UNITED STATES PATENT AND TRADEMARK OFFICE

Office Action Summary

10/535,049

SAMUELSSON, ULF

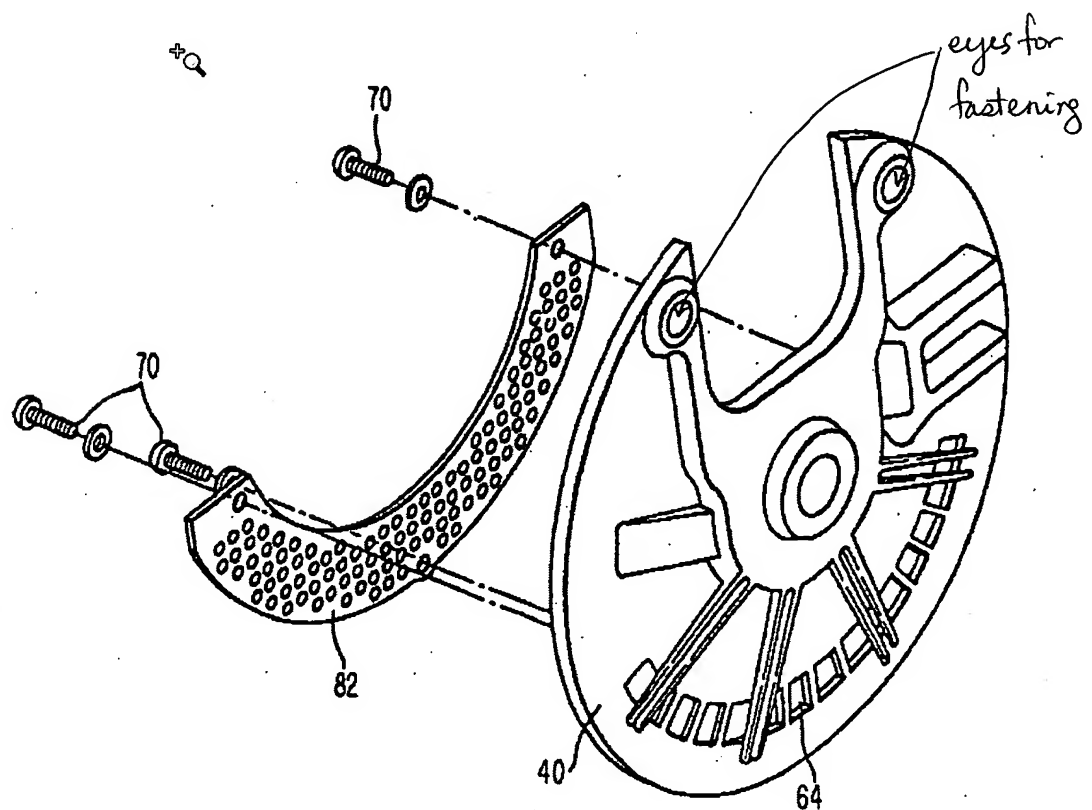
Re: claim 1, Borlinghaus shows a disc brake, as in the present invention, comprising: a disc brake including a protective shield, a wheelshaft 6, a brake disc 2, brake yoke 3 with a pair of supports 4, protective shield 8 as claimed; a protective plate 11, 15, a fastening bracket 14 to be fastened to the brake supports at 12 wherein the protective plate and the fastening bracket are separate elements which are united with each other via connecting portion 9.

Re: claim 2, figure 3 shows the protective shield to be U-shaped. Please see the drawing objection above. Applicant's drawings do not show a U-shaped cross section but shows a U-shaped protective shield 9 in figure 2. Claim 2 is being treated as claiming a U-shape protective shield.

Re: claim 3, figure 3 shows the fastening bracket portion 14 are divided into two separate fastening brackets, one on the left and one on the right.

Re: claim 10, figure 1 shows supports 4 having fastening eyes at 12.

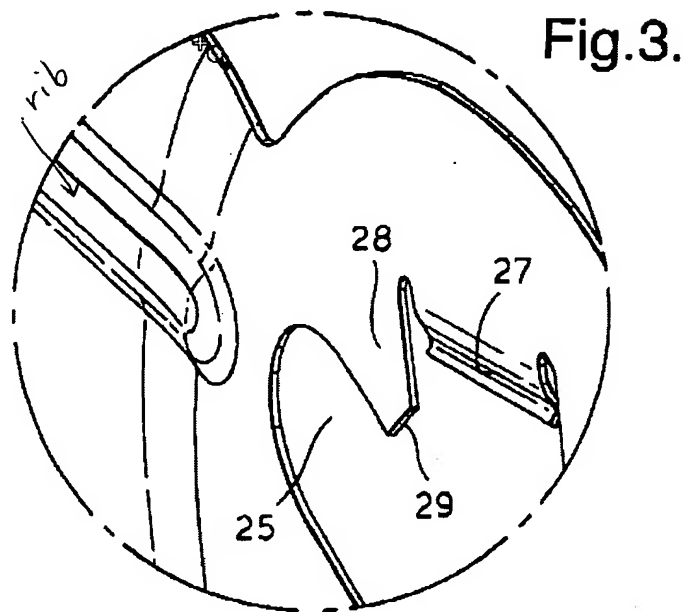
Re: claim 1, Kawaguchi shows a disc brake in figures 16-18, as in the present invention, comprising: a disc brake including a protective shield, a wheelshaft 12, a brake disc 24, brake yoke 32 with a pair of supports, protective shield 40, 82, 84 as

claimed; a protective plate 82 a fastening bracket 40 to be fastened to the brake supports as marked below, wherein the protective plate and the fastening bracket are separate elements which are united with each other via bolts 70.

Re: claim 3, figure 17 shows the fastening bracket portion 40 are divided into two separate fastening brackets, one on top and one on bottom.
